# 301 NE NORTHGATE WAY

CITY OF SEATTLE DESIGN REVIEW

DESIGN RECOMMENDATION REVIEW  
DPD PROJECT # 3018742  
SEPTEMBER 28, 2015

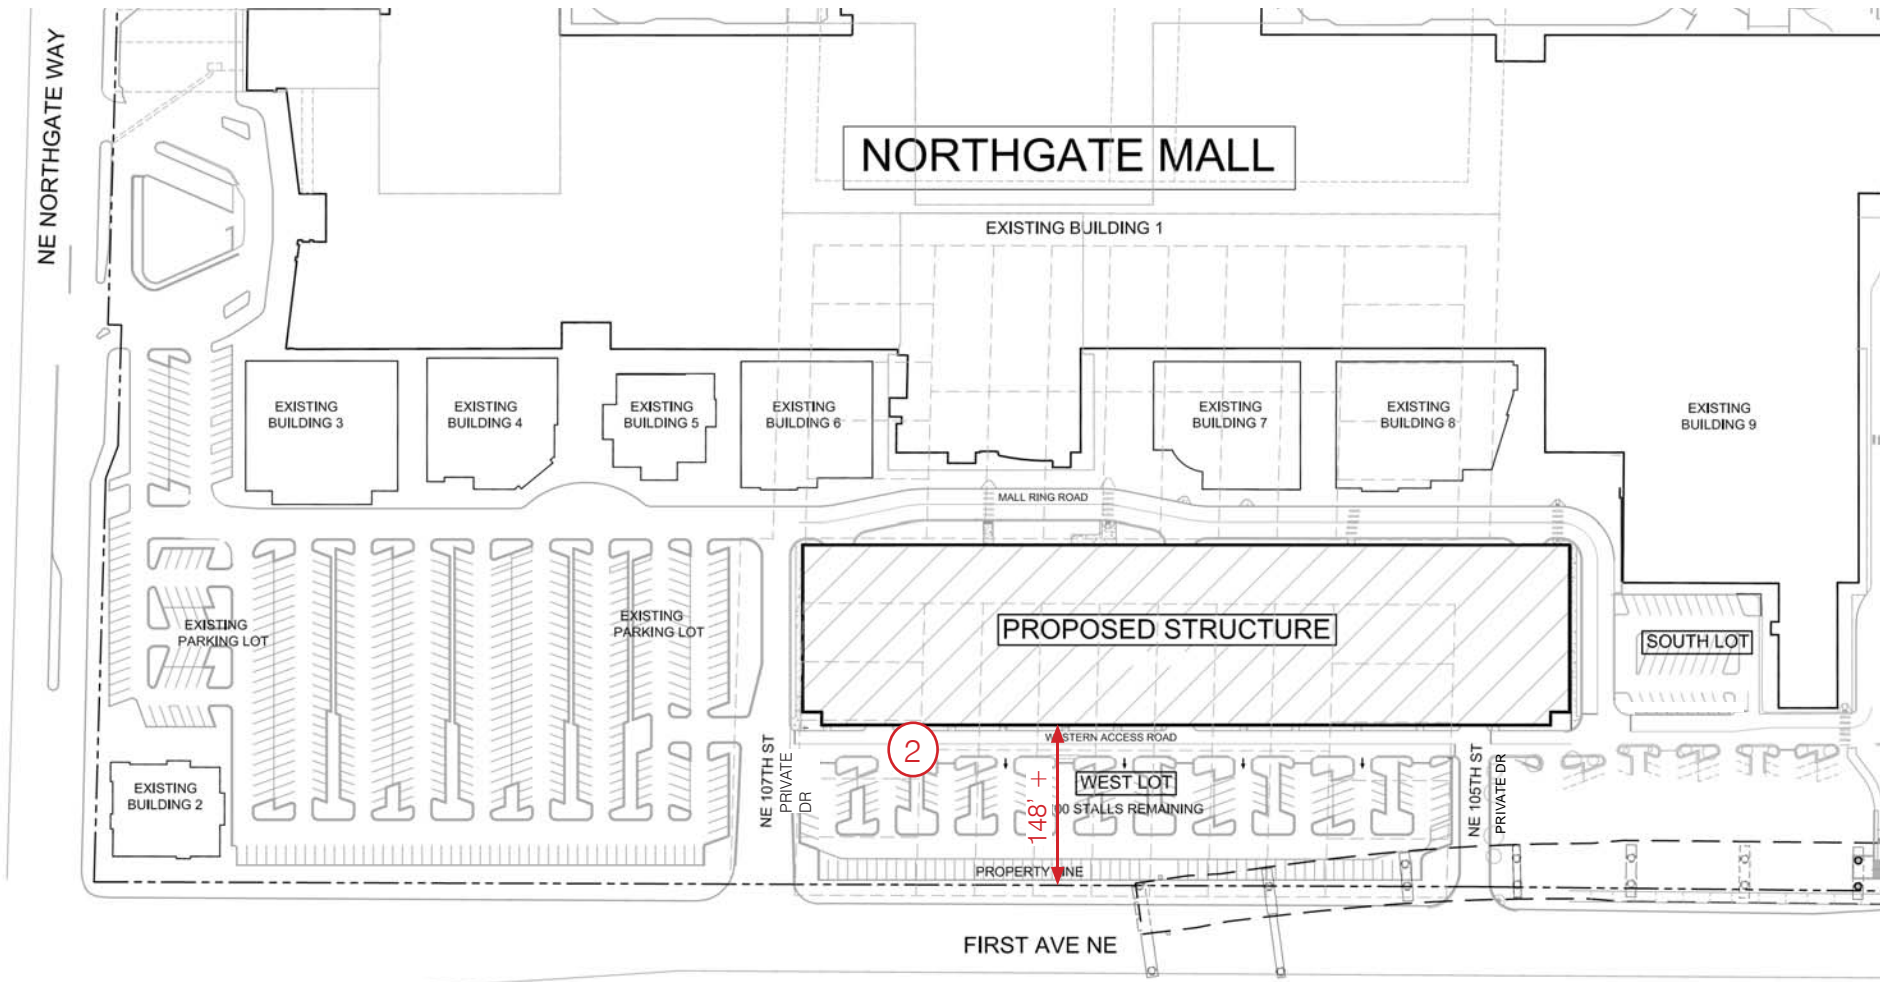
a. Massing.  
The Board expressed general support for the low-profile, two-story massing of the applicant's preferred alternative. The Board considered how the lower profile massing provides more opportunity for the structure to visually integrate into the site and be treated more of a landscaping feature and less as a structure. The Board directed the applicant to focus on the ground level and landscape response to better integrate the structure into the site. At the Recommendation meeting, the applicant should provide elevations, cross sections, and perspectives. (CS1-C, CS2-D-2, & DC2-A-1)

Response:  
Perspectives, renderings, elevations, and cross sections have been incorporated into the Design Recommendation packet to demonstrate how the massing of this parking structure is minimal, ties into the existing site grades to minimize impact on the site, and visually integrates into the site. Due to the significant landscaping by the addition of greenscreen on the blank concrete shearwalls and partial retaining walls, landscaping between the structure and the existing uses, and added landscaping throughout the top deck, this structure visually integrates well into the existing site as can be seen in the site sections and renderings in the Design Recommendation packet.

See pages 28-29 for rendered site sections and elevations, pages 31-34 for rendered perspectives, and pages 24-27 for rendered landscape plans and landscape examples. An example of a site section is shown below.

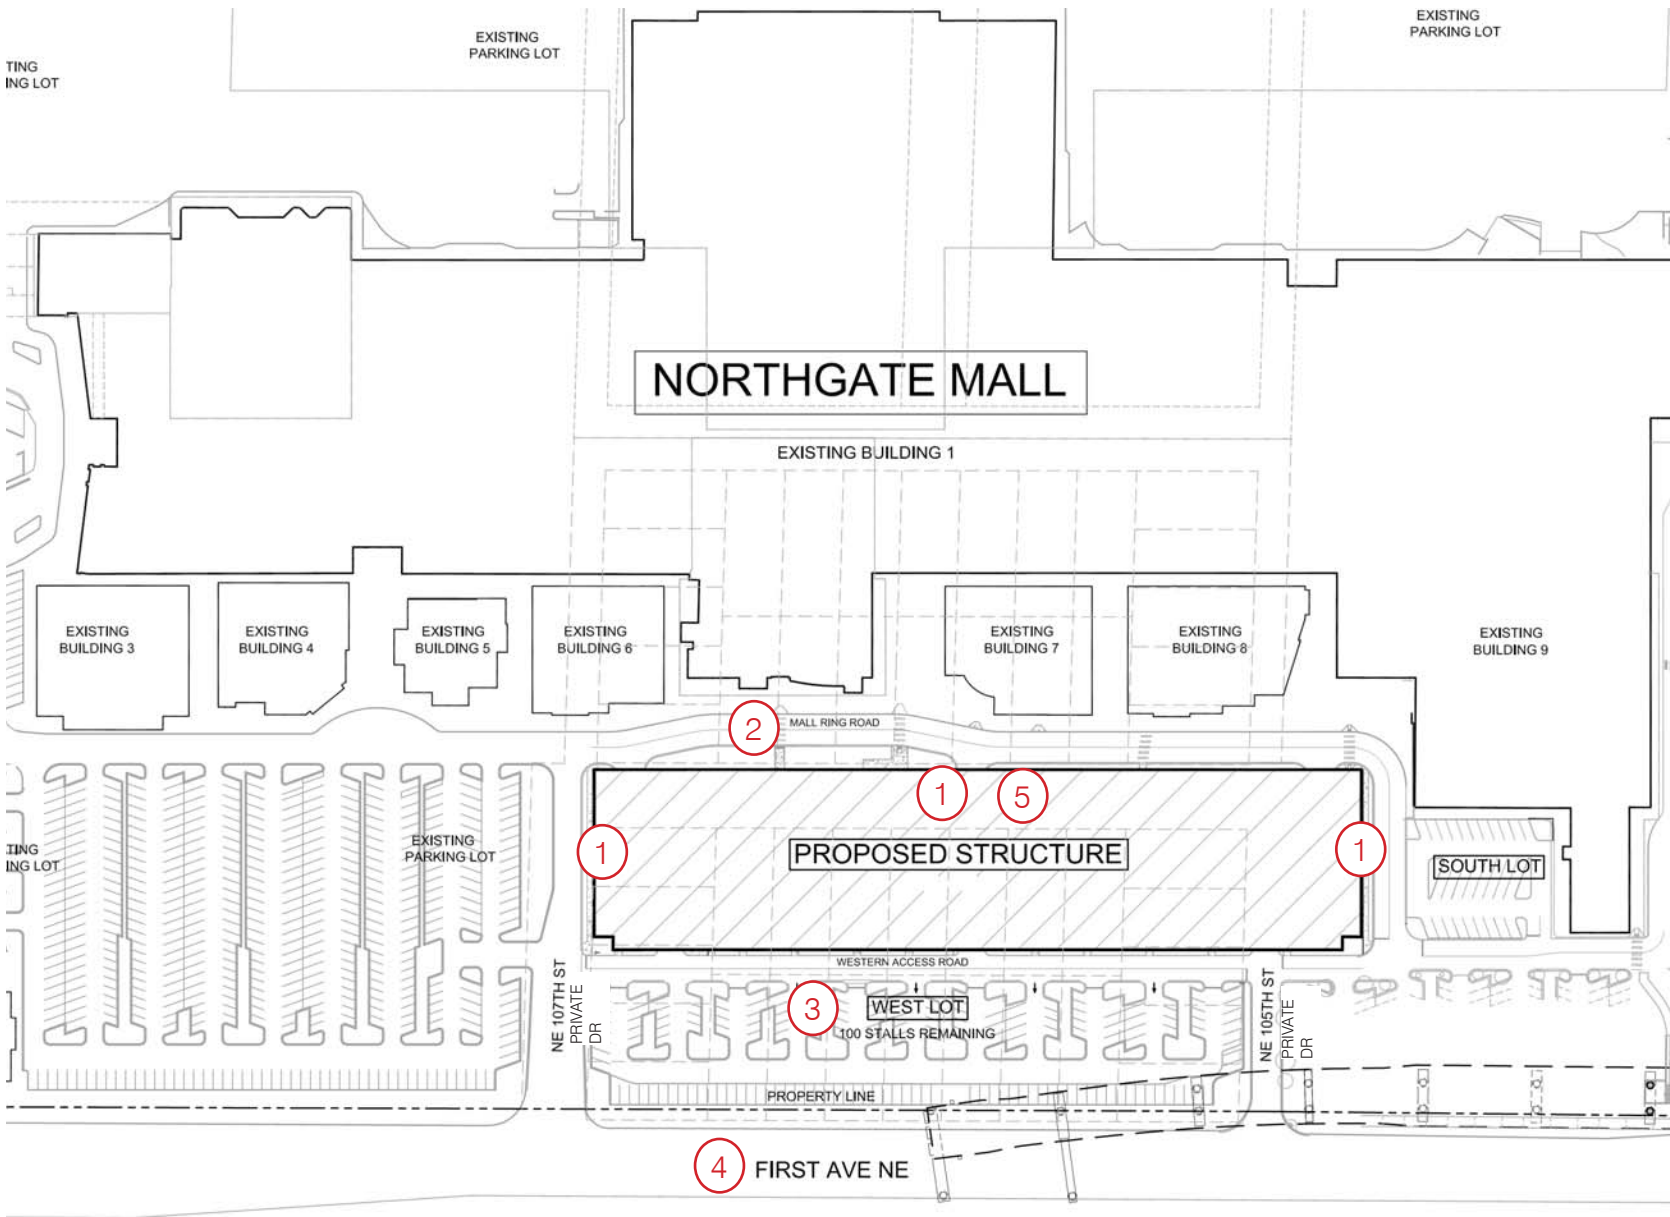
The Board directed the applicant to provide additional study and analysis on a 13' floor-to-floor height for the proposed parking structure to better accommodate possible future reuse of the structure and create a more comfortable pedestrian experience. The analysis should consider how a 13' floor-to-floor height would impact the overall project design while still integrating the structure into the natural topography of the site. (CS1-B-2, PL2-B-3, DC1-A-3, & DC-1-III-ii)

This was studied and it was determined that this was not feasible across the entire project length nor suitable for this project site. The existing site grades control whether this is feasible since the structure integrates into the existing site and ties into the adjacent roadways. 13' floor to floor is generally used for building structures and not typical for parking structures. The guideline is intended for a street front pedestrian experience and since this project is not on the public ROW, this design guideline is not applicable. Instead, the project meets Northgate Design Guideline DC1.III.i "Site parking structures away from Major Pedestrian Streets," as the project is located more than 140' from 1st Ave NE. This is outlined further in the departures table for street-level street facing development standards and in the diagram below.

Further, if this parking structure were to be used for retail space in the future, the best option for future street-level street facing retail on this project is the upper floor, facing the mall ring road, for the following reasons:

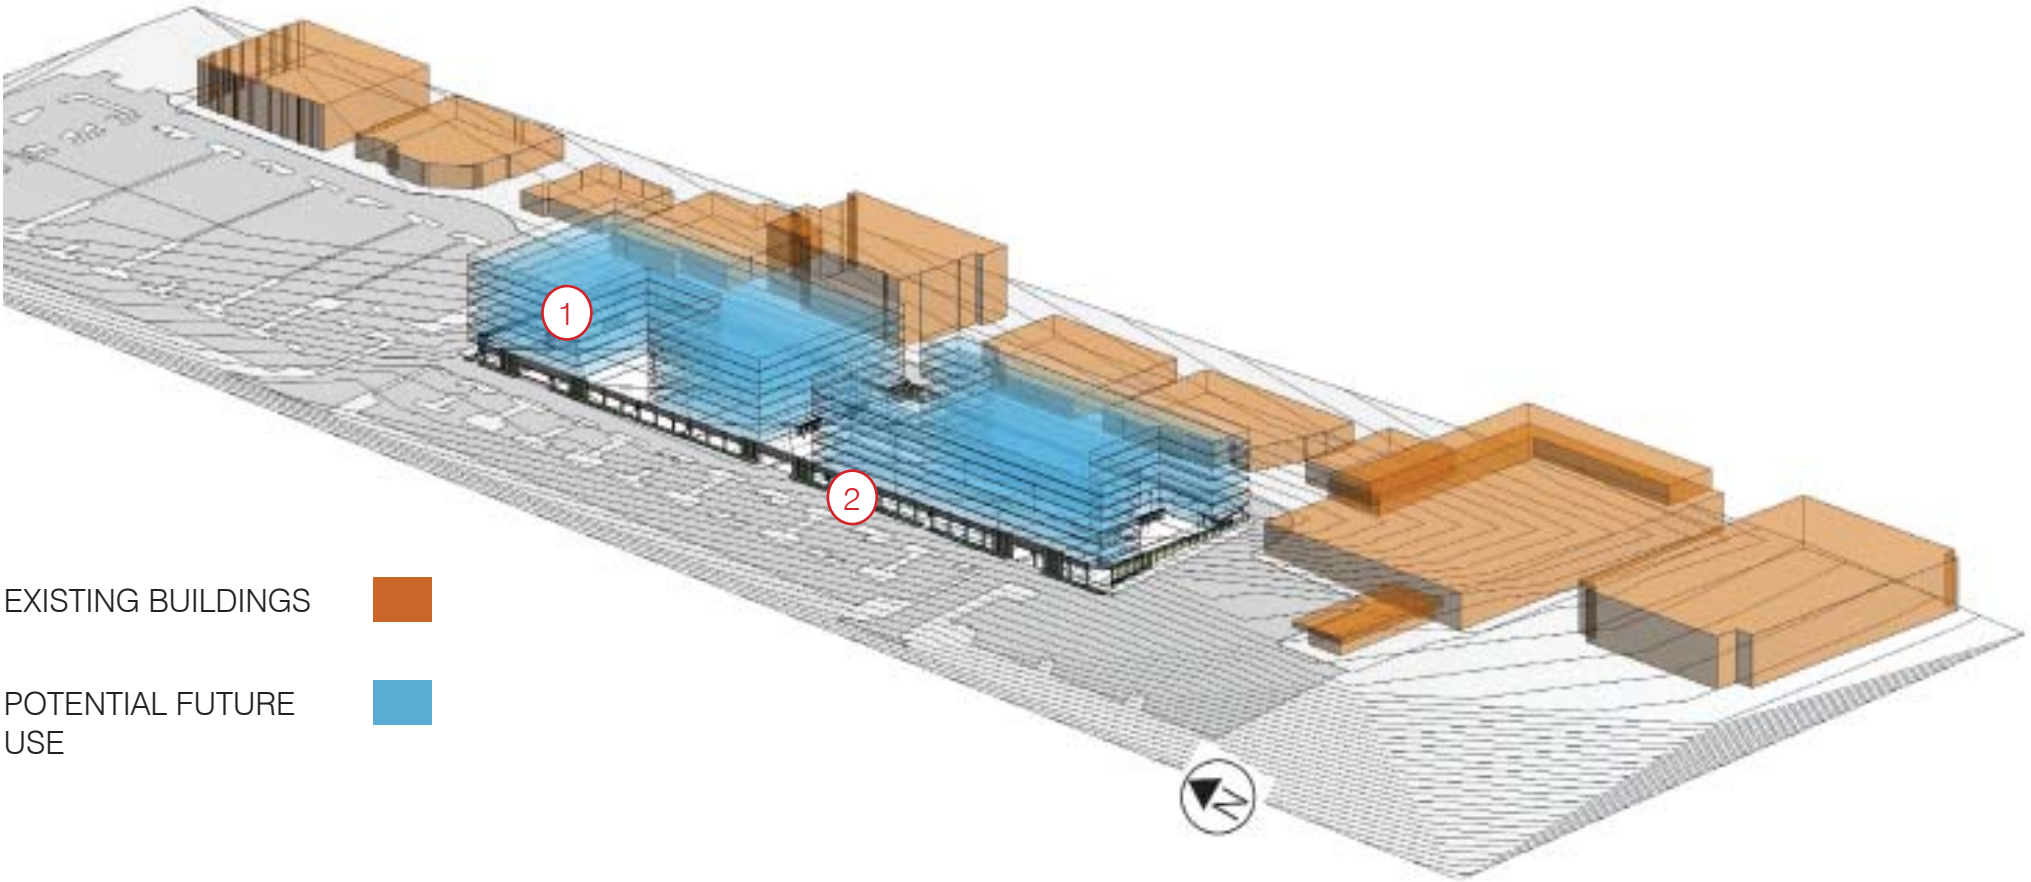
a. Flexibility.  
The Board expressed concern with the project’s parking-only use because the location is zoned for higher density, mixed-use development and proximity to mass transit. The Board discussed the need for the design to be adaptable and flexible for future use and development potential. Specifically, the Board directed the applicant to study how the project could be built to structurally accommodate future development (on top of the structure) up to the 85’ height limit. (DC1-A-3 & DC4-E-1)

Response:  
This was studied and with modifications in the future and significant costs, the current design can allow for future development. The current project does not preclude any future development on the site. The below graphic shows how the proposed project could be used as a platform for further development in the future, while nothing is planned at this time.

Additionally, 85’ building heights are not part of any future business plan for the mall and are not permitted by both tenant leases and the existing development agreement. With the current lease commitments, buildings that would block the visibility of the existing tenants are not allowed. It would be difficult to keep tenants without visibility thus creating additional vacancies. This parking structure configuration needs to have at the very least a 20 to 25 year life span due to existing tenant leases. The proposed deck, therefore, satisfies the tenants’ requirements in that the parking structure does not materially or adversely impact the visibility their leases call for (that they have rights to until their terms and options expire). Yet it also satisfies the long term goals of the City in that it is not so substantial that when that time comes, it cannot be replaced or revised as appropriate, subject of course to a thorough land use re-view/approval process and SEPA analysis for that subsequent opportunity, to relevant codes and processes at that time, that would likely be different than today.

Further, the leases with JCP and Nordstrom REQUIRE that lost parking be replaced (that Sound Transit will be taking for upwards of three years) exactly where the deck is shown.

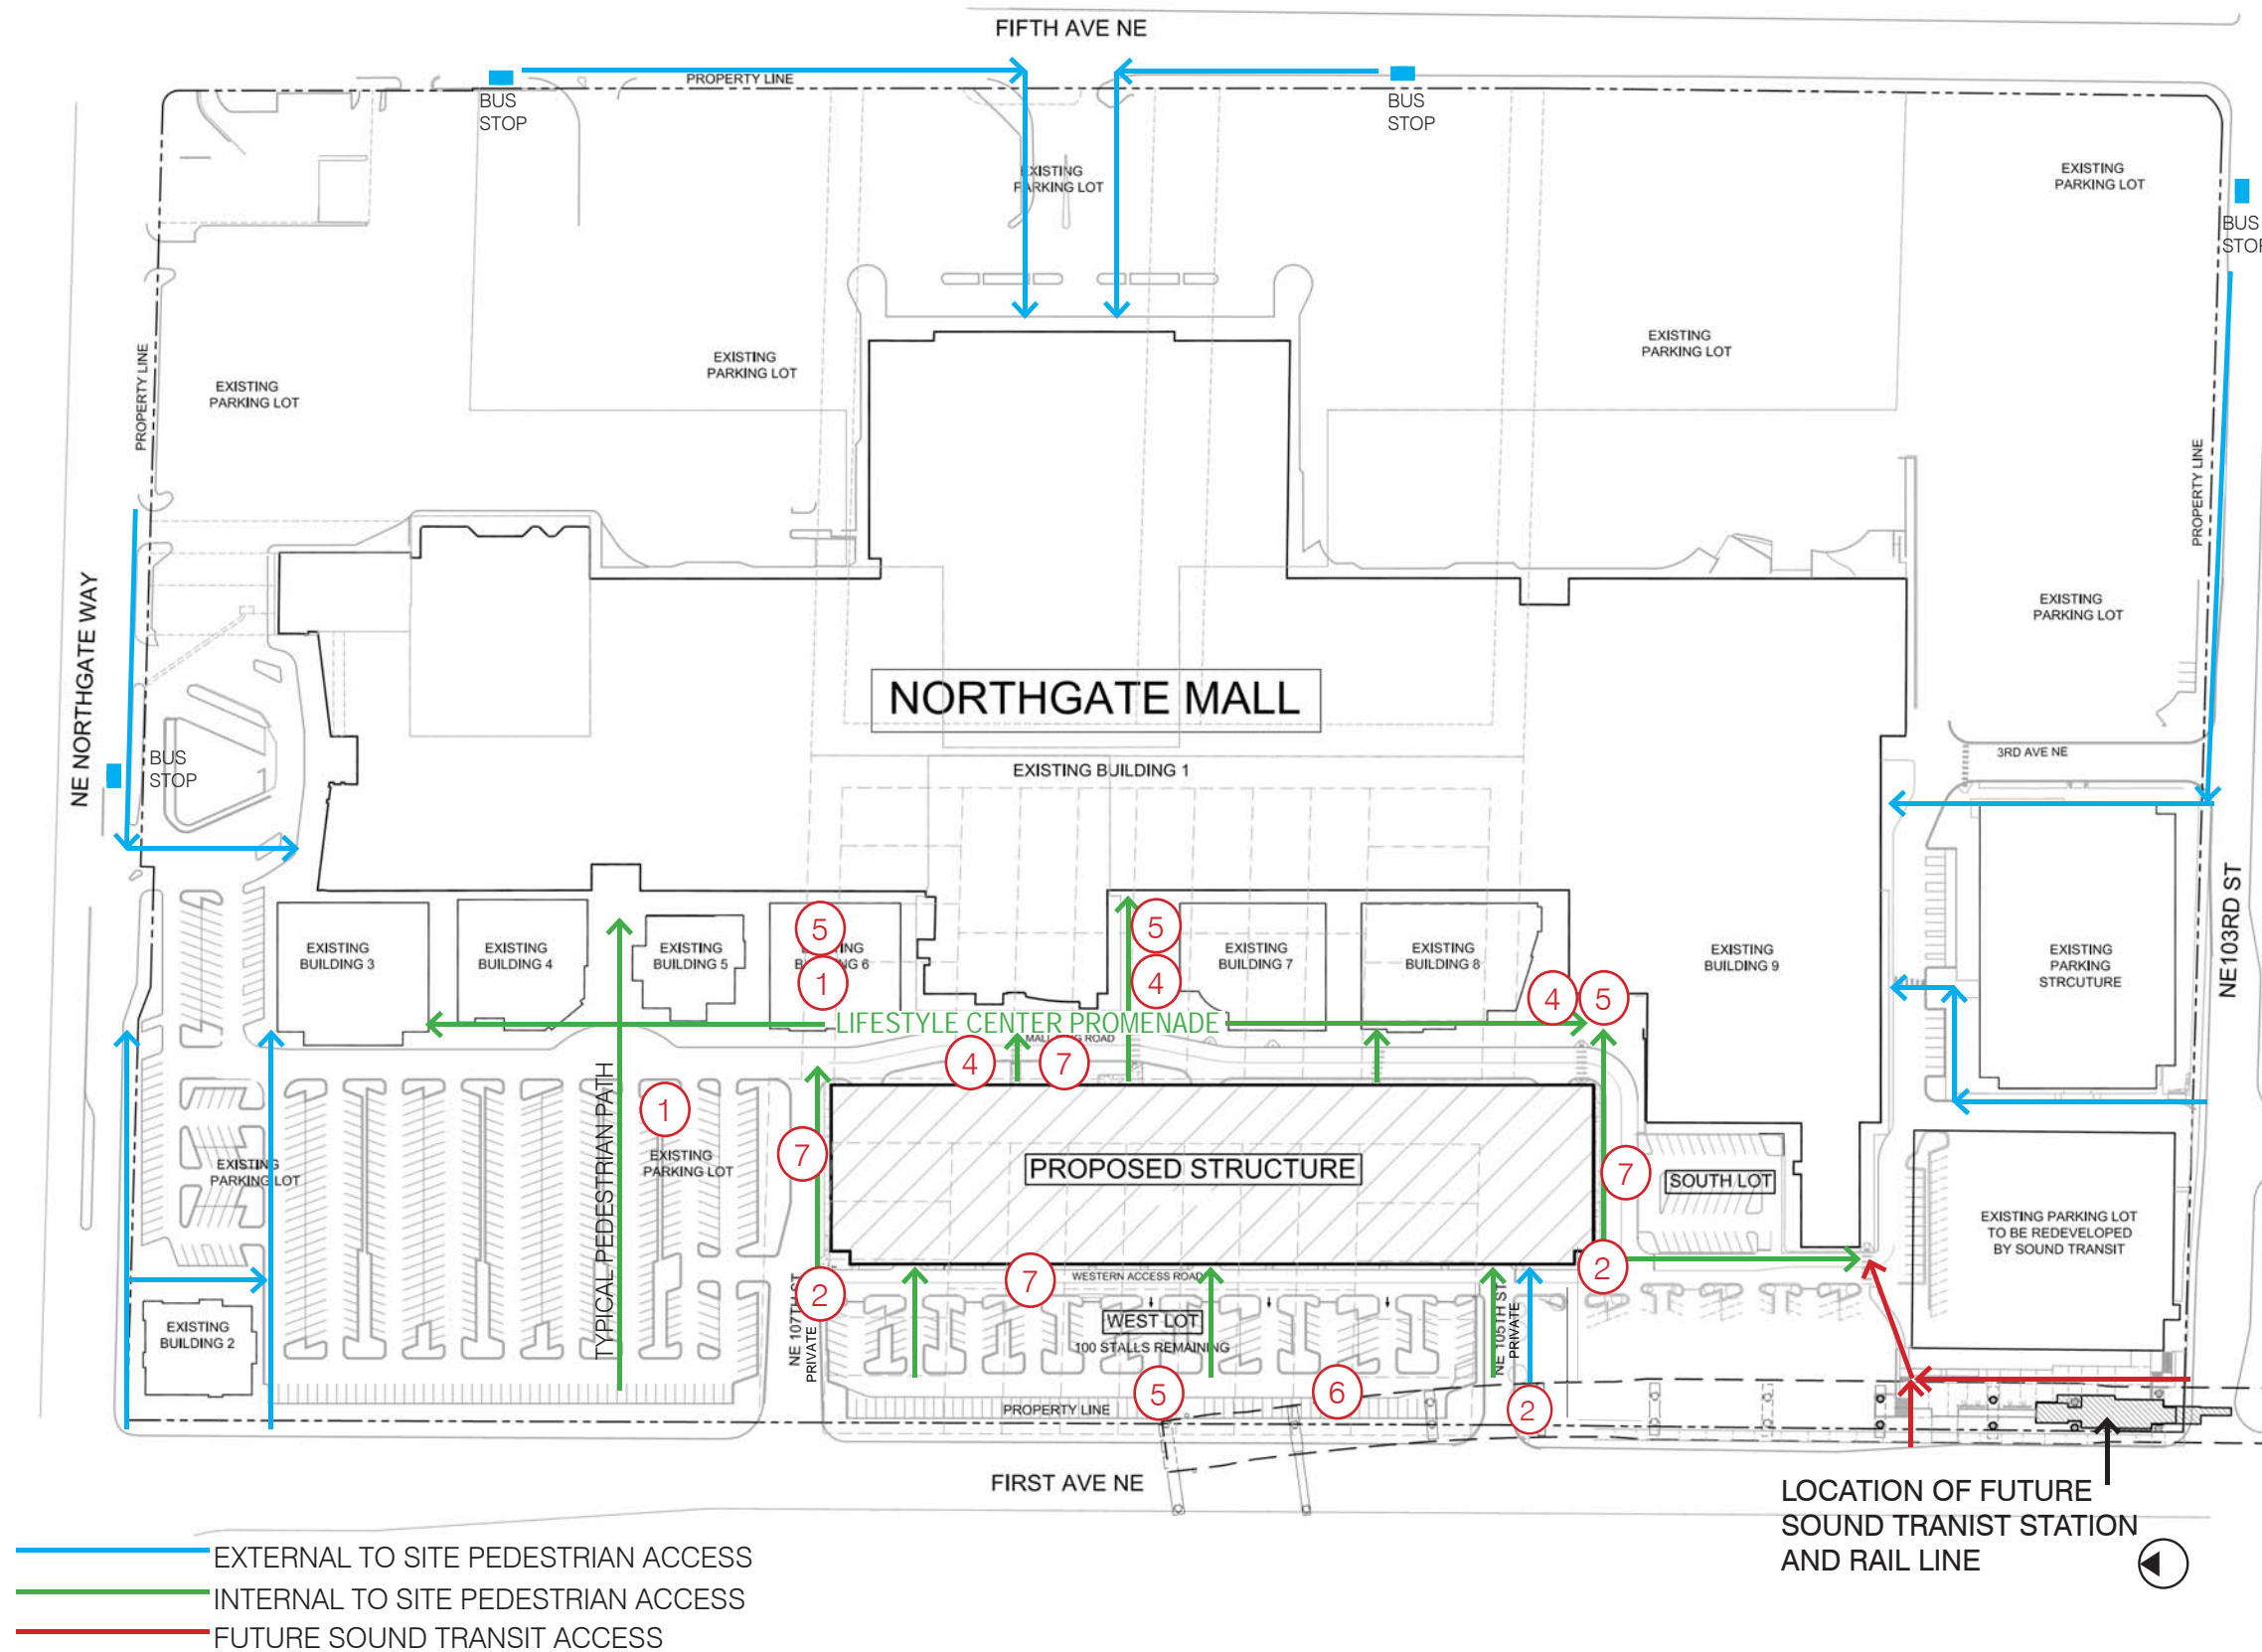
a. Landscaping.  
The Board discussed that because of the topography and proposed massing, the structure has the potential to blend into the site and would appear as surface parking from some vantage points. The Board directed the applicant to take cues from the pedestrian walkway, open space, and landscaping requirements for surface parking and integrate these features into the project design, specifically on the second story of the structure. (CS1-D-1, PL1-B, PL1-I, PL2-III-vii, & DC1-I-i)

Response:  
Significant landscaping has been added since the EDG meeting, including trees and planters on the top deck. No departure is needed for open space or landscaping. Green Factor, Landscaping, and Open Space thresholds have all been met for this project. Additionally, the following have been included in response to the EDG comment and to the Design Guidelines listed below. Many are above what is specifically required by Land Use Code.

- 1 Tree planter boxes and low planters with ground cover or low shrubs have been added throughout the top deck in a frequency similar to what is required for surface parking as requested at the EDG meeting. See colored landscaping plan on page 24.

- 2 The whole row of front row stalls along 1st Ave NE within the project boundary has been removed and replaced with landscaping.
- 3 Both the northwest and southwest corner of the structure have been notched and landscaped with tall trees that will reach above the upper level. This will provide less surface area of concrete, more greenery, and a softening of the corners when entering the site.
